Access Compliance Report

Public Rights-of-Way

Intersection ID: 27772	Main Street: BRIARWICK_LN	Cross Street: NORTH_COMMUNITY_HOUSE_RD	Location: SE
ADA ID: CD251376959F	Ramp Type: Perp	Initial Pass/Fail: Fail	Overall Compliance: No
		Severity Score: 42.5

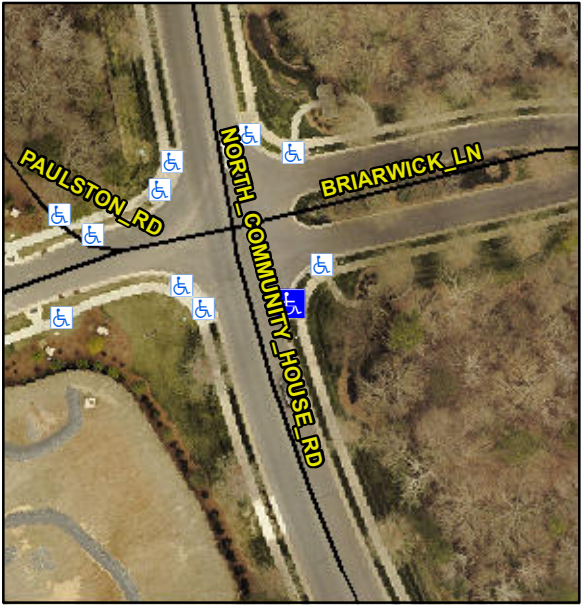
Codes/Mitigation Info/Possible Solution			Field Measurements/Component Compliance		
	Possible Solutions:		Compliance	Description	Data
	Remove & Replace Entire Ramp.		No	Ramp Length (in)	108.0
			No	Ramp Width (in)	35.0
			N/A	Flare Type LT	N/A
			N/A	Flare Slope LT (%)	N/A
			N/A	Flare Traversable LT?	N/A
			N/A	Landing Length (in)	N/A
			N/A	Landing Width (in)	N/A
			N/A	Landing Slope (%)	N/A
			N/A	Landing X Slope (%)	N/A
<p>Surveyor Notes:</p> <p>N/A</p> <p>PROW/ADA:</p> <p>R304.5.1, R304.2.2, R304.5.3</p>			N/A	Flare Type RT	N/A
			N/A	Flare Slope RT (%)	N/A
			N/A	Flare Traversable RT?	N/A
			N/A	DWS Provided?	N/A
			N/A	DWS Contrast?	N/A
			N/A	DWS Length (in)	N/A
			N/A	DWS Full Width?	N/A
			N/A	DWS Offset (in)	N/A
			N/A	Gutter Ponding?	N/A
			N/A	Gutter Lip Ht (in)	N/A
<p>Total Cost:</p> <p>\$ 1850.00</p>			No	Painted X Walk1?	N/A
			To W	X Walk 2 Direction	N/A
			N/A	X Walk 2 Width (in)	N/A

10.6	X Walk 2 Slope (%)	N/A
			1.5	X Walk 2 X Slope (%)	N/A
			N/A	Ramp inside XWalk1?	N/A
			N/A	Ramp inside XWalk2?	N/A
			N/A	Clear Space?	N/A
			N/A	Clear Space to XWalk (in)	N/A
			N/A	Storm Grate/Utility Hazard?	N/A
			N/A	Storm Grate/Utility Type	N/A
			N/A	Surface Condition? (G/P)	Good
